Technical Service Bulletin

**ENGINE TEMPERATURE AND HEATER PERFORMANCE
CONCERNS WITH OR WITHOUT DTC P0126:00**

Bulletin No.: 01-001/26

Last Issued : 01/30/2026

Fig. 1: Shows correct orientation with the flat side (or short end) of the dummy plug (with o-ring) going into the upper hole (see arrow) of the CCV.

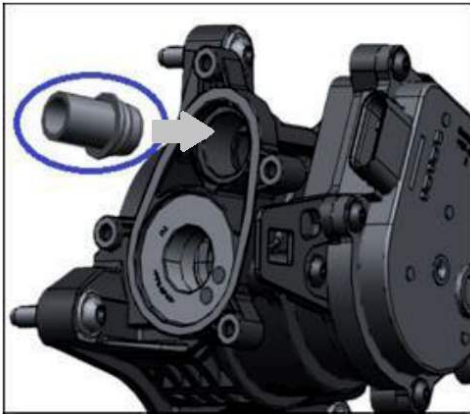
- Pay close attention to the orientation of the dummy plug when installing it into the coolant control valve (CCV).
- DO NOT force the dummy plug in the wrong direction.
- If the dummy plug is installed in the wrong direction, it may cause DTC P0126:00 to return and slow heating of the HVAC system.
- Be aware that Fig. 1 and Fig. 2 (below) are both correct, but show the dummy plug orientation from opposite ends.

NOTE: Be sure to install the dummy plug into the correct CCV hole.

Fig. 2: Correct dummy plug (4) orientation to the thermostat cover (2).

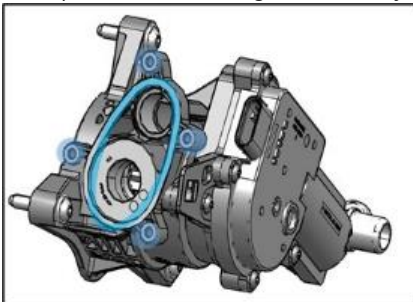
1. Thermostat cover gasket*
2. Thermostat cover
3. Water outlet gasket
4. Dummy Plug

- a) Before installing the dummy plug into the CCV, check the mounting area for dirt and clean the area.

- b) When installing the dummy plug into the CCV, push it firmly until it makes a clicking noise to ensure it has been installed properly.
